2022MY
Carnival (KA4)

060 (Rev 1, 05/23/2025)

TECHNICAL SERVICE BULLETIN

CYLINDER IMBALANCE DTC P219XX00 INSPECTION
AND INJECTOR REPLACEMENT

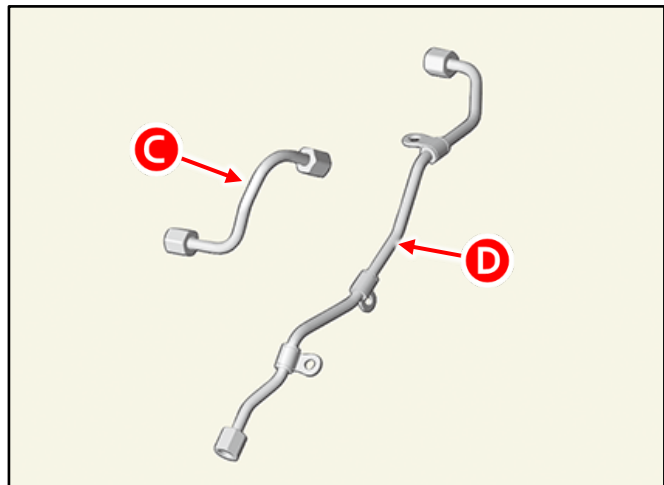
1. Replace the high-pressure injector(s) on the affected cylinder(s) by referring to the 'Engine Control/Fuel System → Fuel Delivery System → Injector → Removal and Installation' in the applicable shop manual KGIS.

DO NOT re-use the removed parts.

The 'new' injectors are supplied with new O-Rings (B).

DO NOT re-use the removed parts.
Replace the high-pressure pipe (C) and cross-over pipe (D) with new parts.
